CERTIFICATE OF APPROPRIATENESS

Property: 1917 Crockett St, Lot 1, Block 314, Shearn Addition Subdivision. The property is a vacant 2,315 square foot (47' x 49'-3") corner lot.

Proposal: New Construction – Residence

HAHC Action: Approved

BLOCKFACE RENDERING – FRONT FACING CROCKETT STREET

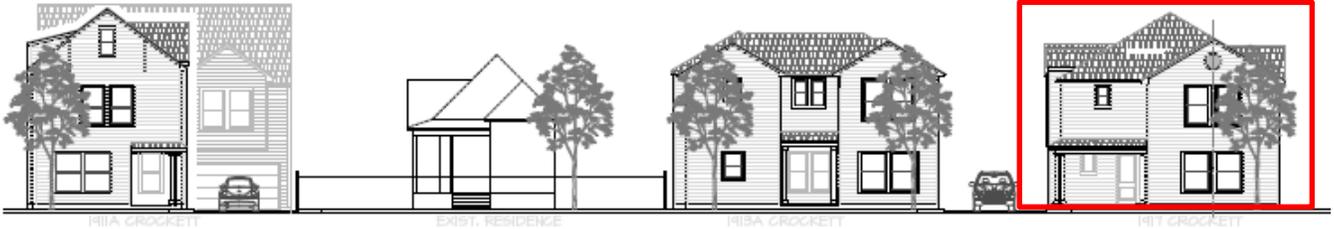
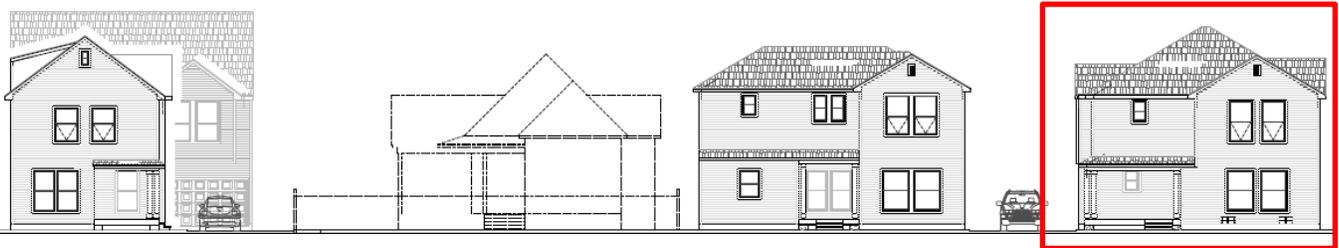
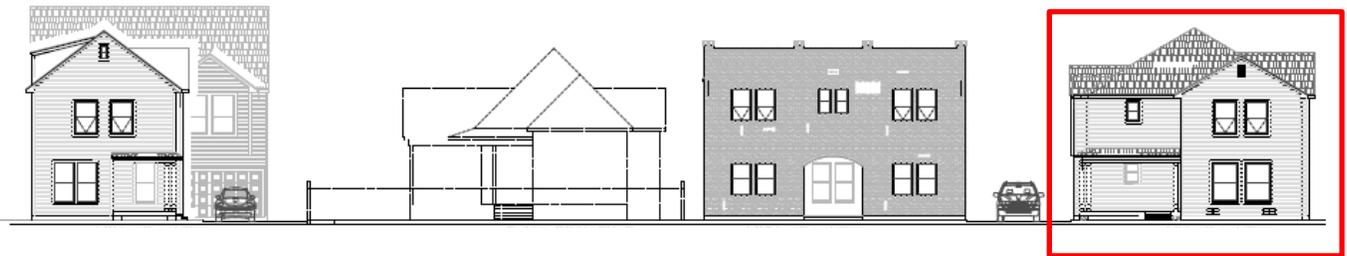
The Design Guidelines have not been officially adopted by City Council. The changes to the residence has resulted in compatible width, height, eave height and window patterns. Width should be no greater than that of contributing structures, which in the context area ranges from 32' wide (1907 Crockett) to 39' wide. There are only two two-story contributing structures in High First Ward (neither in the context area) – one measures 40' wide by 28' tall; the other is 39' wide and 30' tall with a 23' eave.

WEST ELEVATION – FACING WHITE STREET

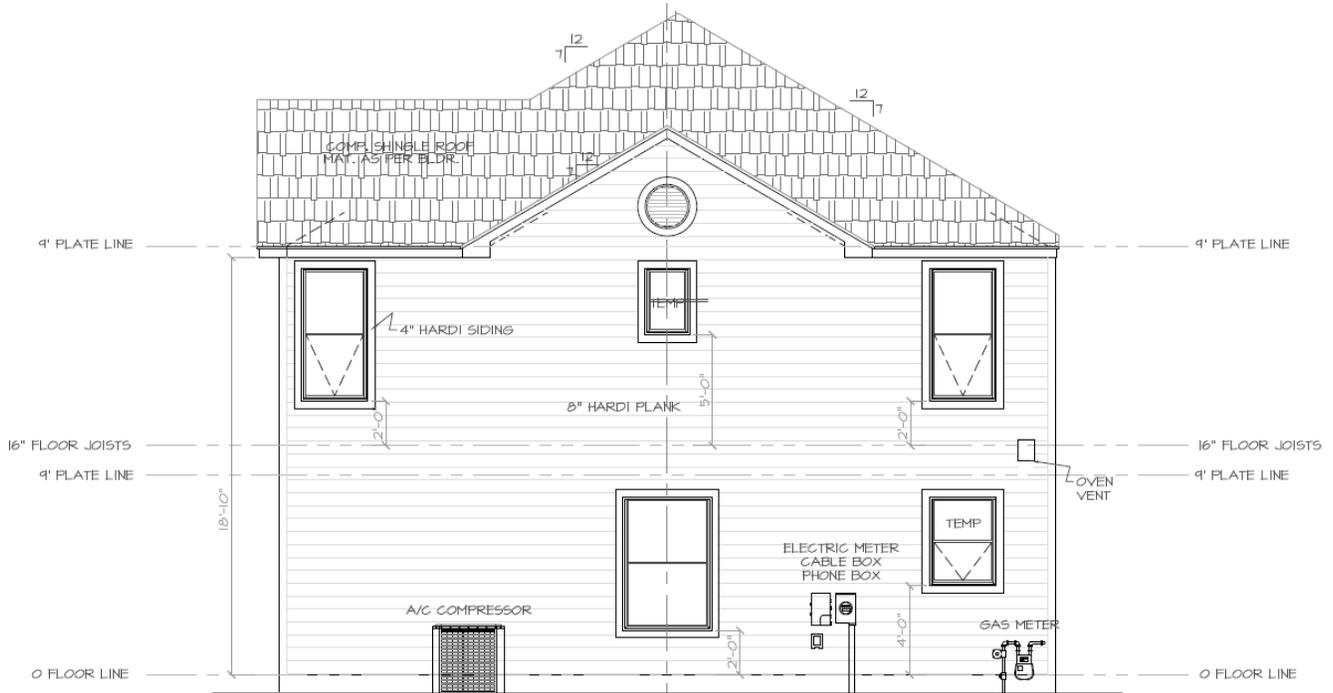
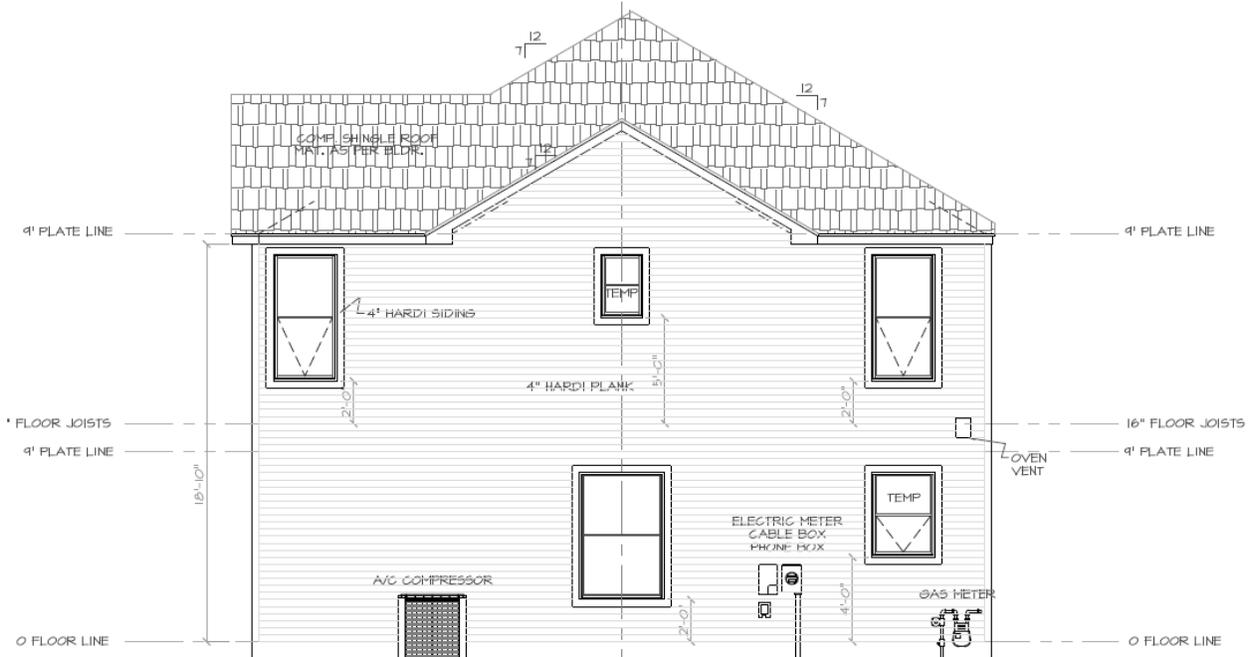
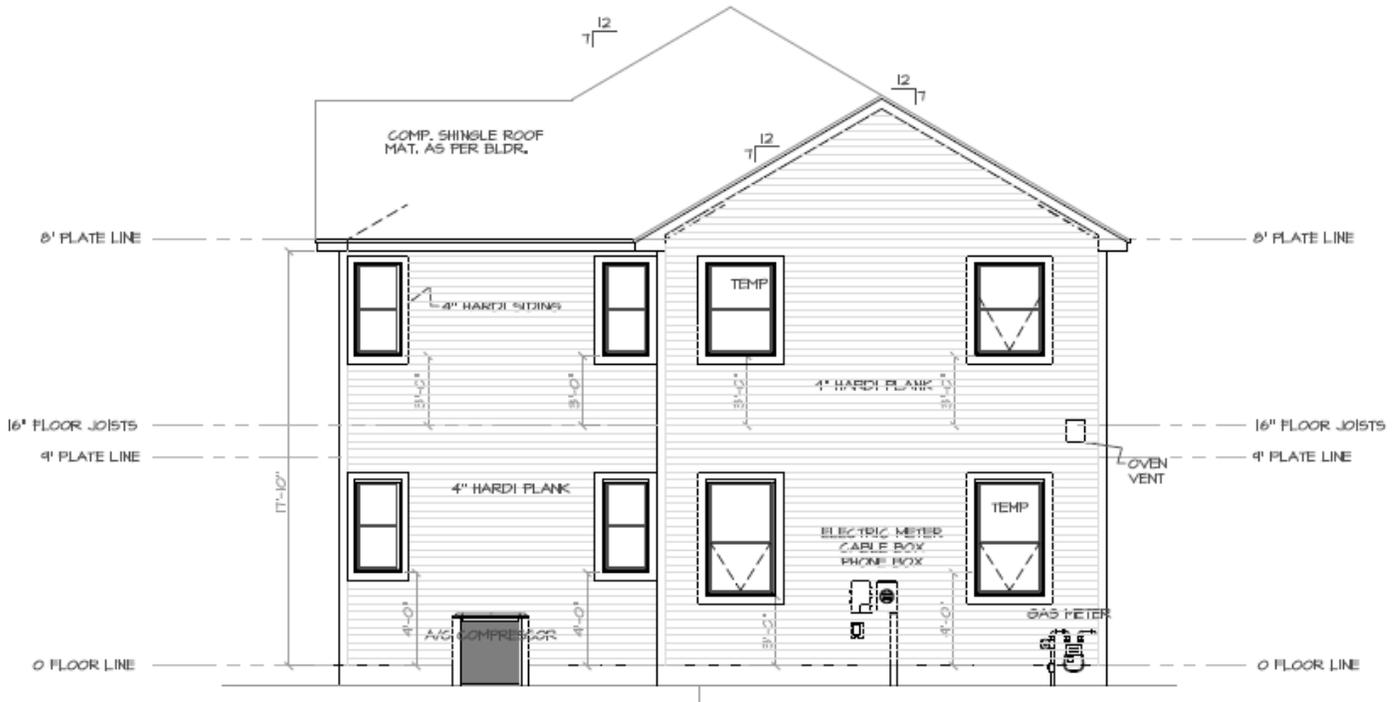
The residence is clad in smooth-finish 4" reveal horizontal lap cementitious siding and contains 1-over-1 windows. The front porch is 6' deep which is a typical depth of porches in the context area. Fenestration was added to the elevations facing White Street and the contributing structure at 1720 White Street.
